SUBJECT: INITIAL EXAMINATION REPORT NO. 50-186/OL-08-02, UNIVERSITY OF
MISSOURI – COLUMBIA

REPORT NO.: 50-186/OL-08-02,

FACILITY: UNIVERSITY OF MISSOURI – COLUMBIA

We have reviewed the written portion of the licensing examination administered at MURR on 5/20/08; and submit the following comments for your consideration:

Question: C.004 [1.0 points, 1/3 each] {4.0}

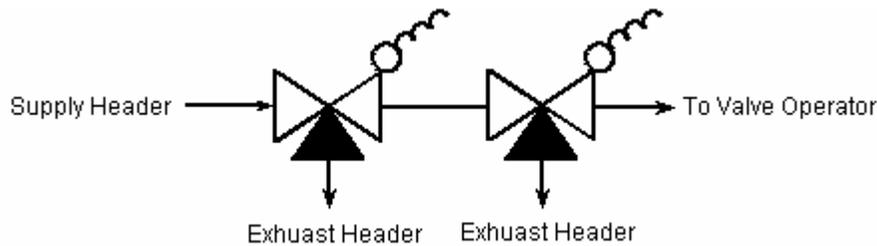
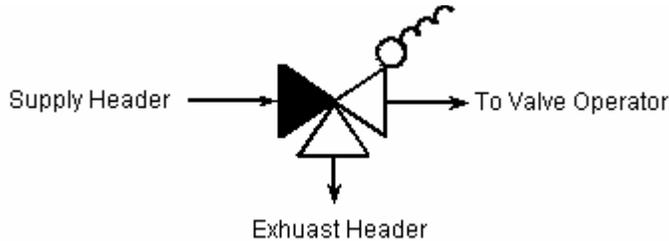
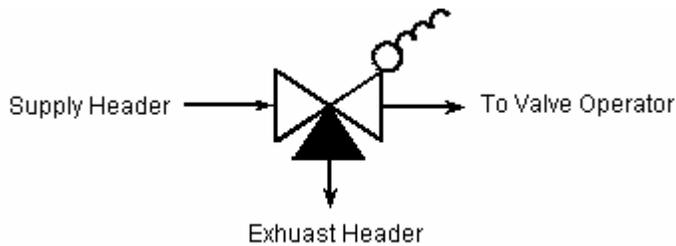
Question C.004 The three-way solenoid valves in the Valve Operating System can be arranged to operate and fail in different configurations. Match the valves listed as A through D with the three-way valve de-energized configuration shown as 1 through 3.

Comments: The answer key indicates ‘a = 3, b = 2, c = 1’, to be the correct answer. Our review indicates no correct answer was available.
The question states solenoid valves in the Valve Operating System fail in different configurations. This is not true, solenoid valves in the system are arranged differently for ‘normal’ operation, yet all the solenoid valves fail in the same configuration [the supply header closes, while the vent and operator ports open].

The configurations shown on the exam illustrate 'normal' operating conditions for solenoids in the MURR Valve Operating System Lesson. All configurations shown in the references are with the solenoid valves in their "normal" operating condition NOT in the de-energized condition.

No D distracter listed.

Suggested changes to the question:

The three-way solenoid valves in the Valve Operating System can be arranged to operate ~~and fail~~ in different configurations. Match the valves listed as A through C with the three-way valve de-energized configuration shown as 1 through 3

Question C.004 deleted from this examination and corrected per facility comment for use on future examinations.
